Town of Parker Community Development Department
 Development Review Division
 Attention: **Julia Duncan**

Application Type: **Site Plan**
 Status: **First Referral**
 Application Name: Parker Pointe F1 AMD 1 L4A - Drive Through Coffee Shop
 Case/AP#: **SP24-128**
 Referral Received: January 3, 2025
 Comments Due: February 3, 2025

Review date: **January 15, 2025**

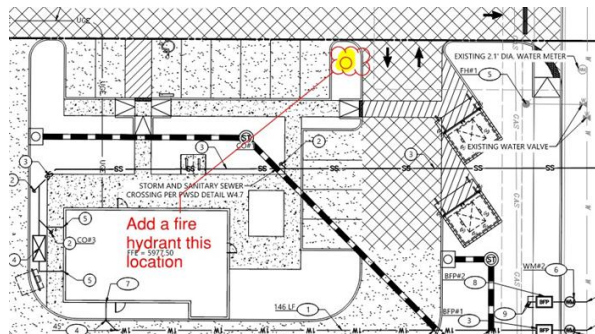
3. The applicant shall be aware that the access road hydrant distribution was not planned to address the suppression needs for all commercial properties within this subdivision; this site requires the addition of one fire hydrant (to be located at the s/e corner island located within 40 feet of the building... as required per NFPA 24 Section 7.2.3). The hydrant shall be located within 40 feet of the building be served with the hydrant located in the northeast island, as required per NFPA 24 Section 7.2.3. *Satisfied; the applicant has noted, acknowledged, or addressed with the second submittal.*

Commentary Figure 503.1.1(3) SMALL BUILDING ACCESS

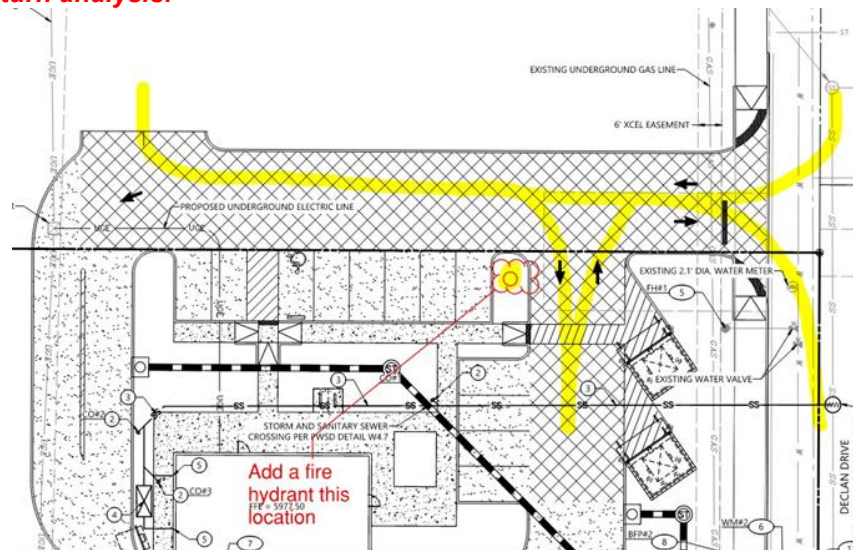
5. Per the requirements of the 2021 IFC Section 503.1.1, approved fire apparatus access roads shall be provided to for every facility such that the requirements of this section extend to within 150 feet of all facility and all portions of all exterior walls of the first story of the building as measured by an “approved route”. In the event that this cannot be achieved, the fire code official is allowed to increase that distance so long as the building is fully sprinklered per 903 of the 2021 IFC. While it appears that the applicant may be able to meet the requirements of the code, the applicant shall prepare and provide an exhibit that “proves that the access can be met. Please note, hose does not bend at 90 degrees and the applicant’s exhibit shall mimic the exhibit provided in the 2021 IFC Handbook. To aid the applicant with what this looks like, please see the following and address this issue when resubmitting (measurement shall be taken centerline of the access road on the north side of the lot. *Not satisfied; the applicant has not provided the information (although indicating that it has been provided). Note – this item cannot be verified as the applicant has not provided a revised site plan (though the applicant has provided a second “Core Electric Response named “Revised Civil Plan Set SUB 02). Satisfied, the applicant has addressed with the third submittal.*

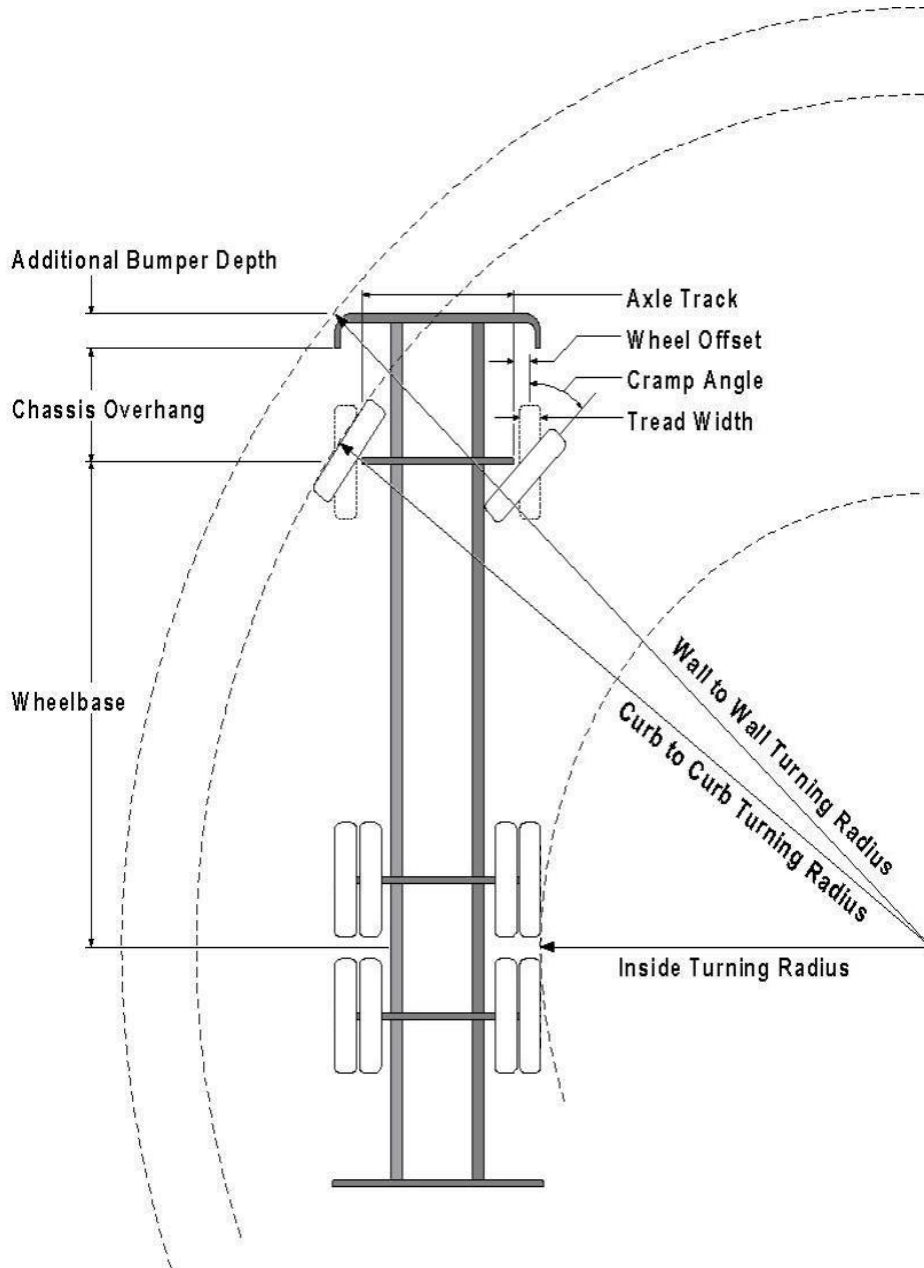
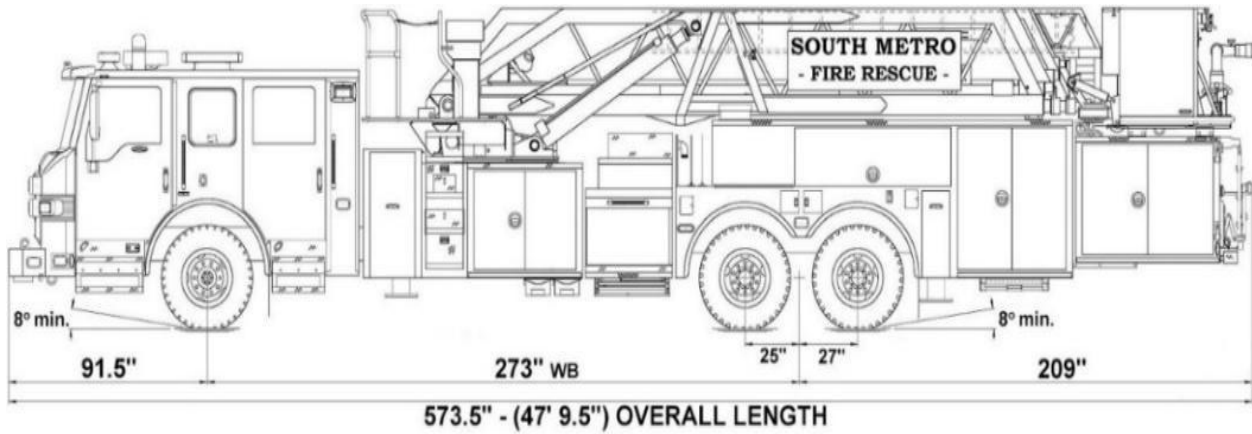
7. The applicant had not provided the required auto turn for the analysis, when resubmitting, provide an auto turn analysis for all areas shown below when resubmitting (note – failure to provide the analysis in all areas will result in delaying approval for the project). *Not satisfied; the applicant has not provided the information (although indicating that it has been provided). Note – this item cannot be verified as the applicant has not provided a revised site plan (though the applicant has provided a second “Core Electric Response named “Revised Civil Plan Set SUB 02). Satisfied, the applicant has addressed with the third submittal. The applicant has provided the required auto-turn analysis.*
